CRYSTAL RIVER NUCLEAR GENERATING PLANT UNIT 3

TECHNICAL SPECIFICATIONS

The Technical Specification activity limits on the primary and secondary coolant for the Crystal River Nuclear Generating Plant Unit 3 have been calculated by the Accident Analysis Branch. The primary coolant noble gas and iodine activities are set by a postulated tube rupture accident and the secondary iodine activity by a steam line break accident. A loss of offsite power is assumed to occur at the same time.

FIGURE 1

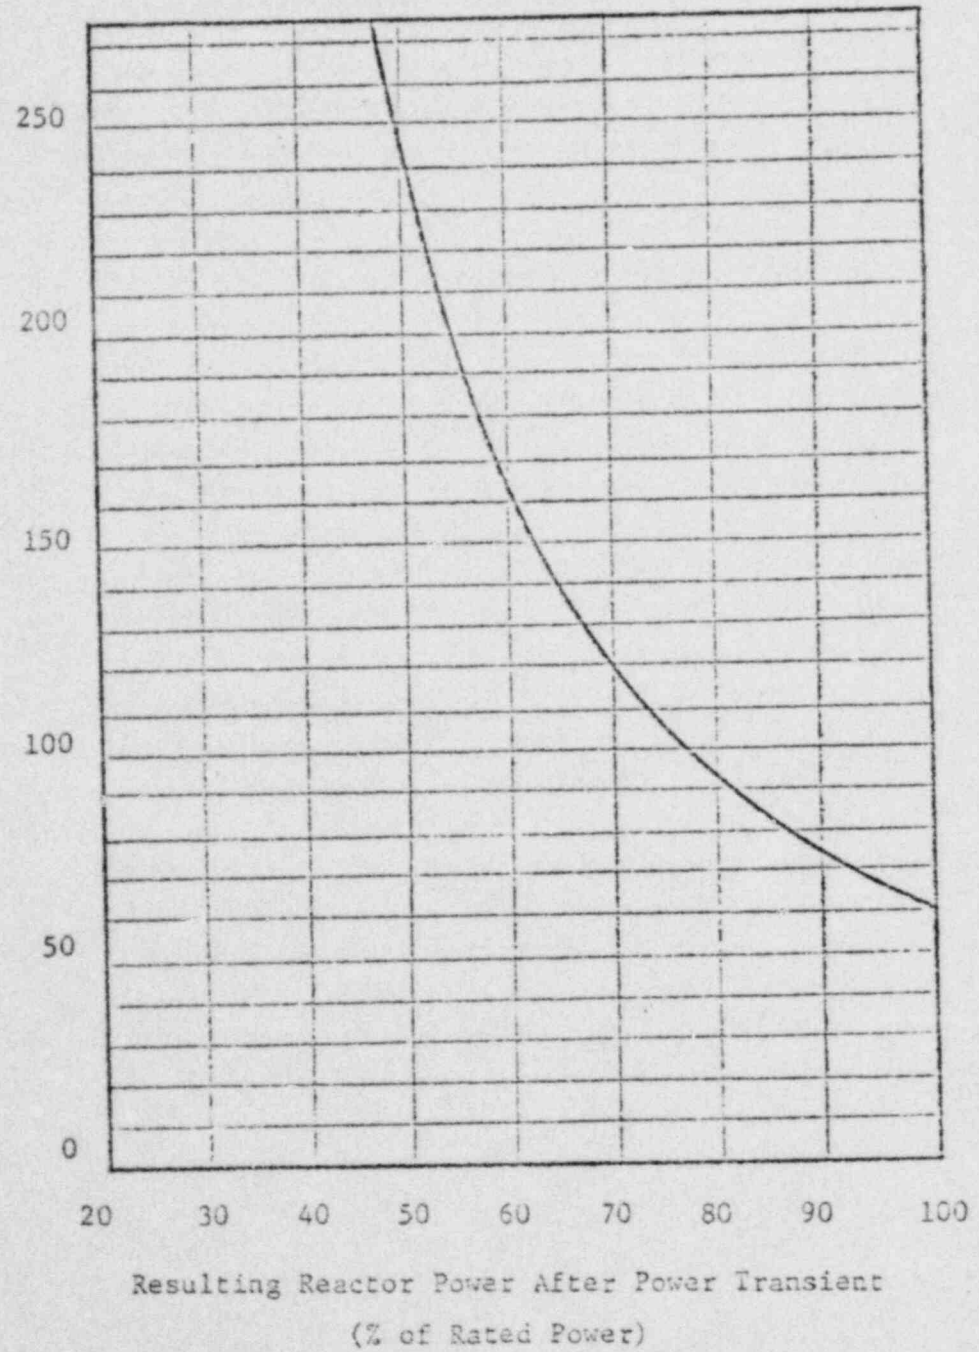
The specific activity of the reactor coolant due to dose equivalent I-131^{1/} shall not exceed 2.0 $\mu\text{Ci}/\text{gram}$ during equilibrium conditions or prior to startup. The iodine activity will be allowed to exceed the equilibrium limit but shall not exceed the maximum values indicated in Figure 1 during 48-hour periods during iodine transients. Operation with a primary coolant activity higher than the equilibrium value, however, shall not exceed 5% of the plant total yearly operating time. The total specific activity of the reactor coolant due to all nuclides, excluding tritium, with half-lives of more than 20 minutes shall not exceed 225/E $\mu\text{Ci}/\text{gram}$.

If the limits specified above are not satisfied, shutdown procedures shall be initiated immediately and the reactor shall be cooled to 500°F or less within eight hours after detection. If the iodine activity exceeds the indicated maximum value the equilibrium iodine activity limit must be lowered by an amount proportionate to the amount by which the 48 hour limit was exceeded.

The allowance to exceed iodine equilibrium activity limits during the specified 48-hour periods following initiation of shutdown or a power transient is made in order to account for possible iodine spiking phenomena. The basis for the allowable maximum values is a resulting dose to the thyroid at the site boundary of 30 rem during the 2-hour period following a steam generator tube rupture accident.
